Class II change apply for WN-111SH (From WN112SH FCC ID: QDWWN112SH)

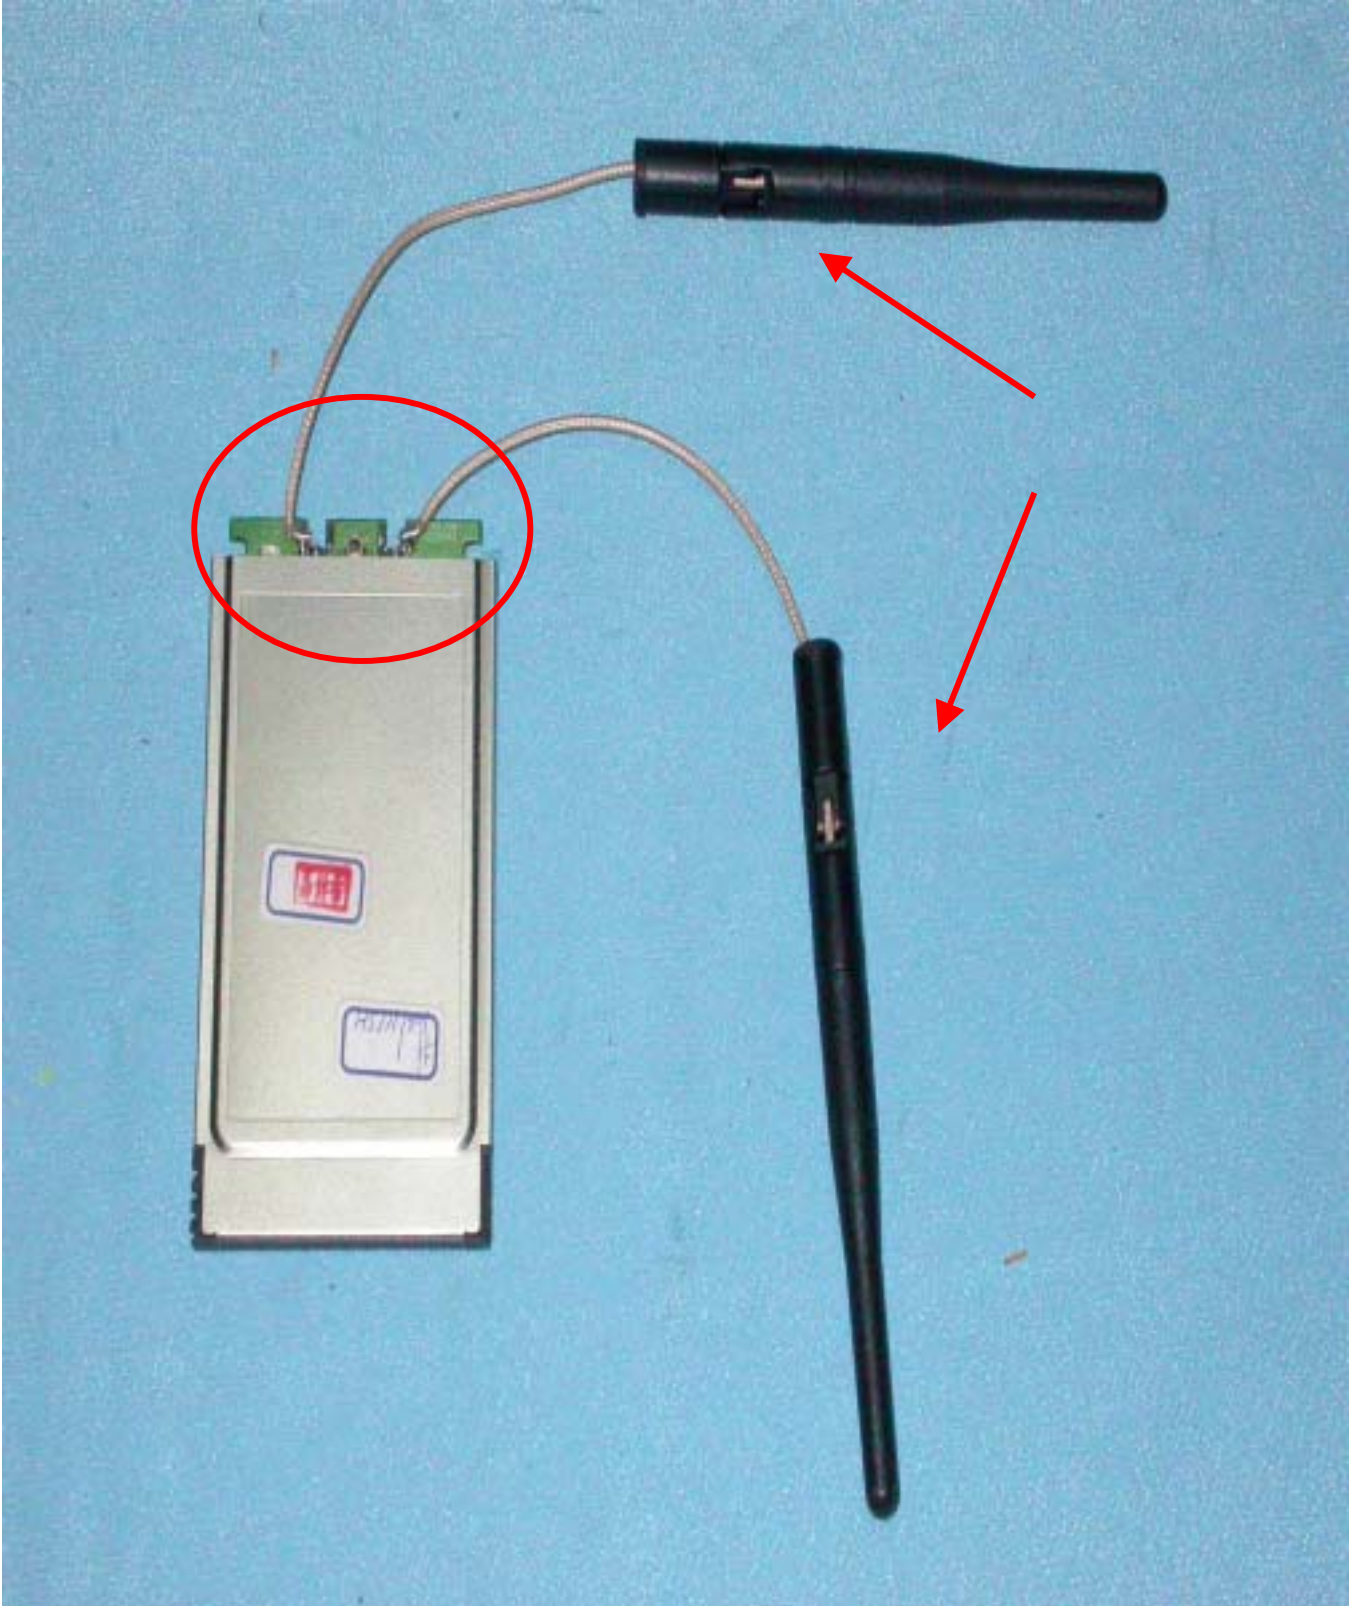
Difference 1—The PCB board is short than original one.

Difference 2—There are two cavities on terminal of PCB board.
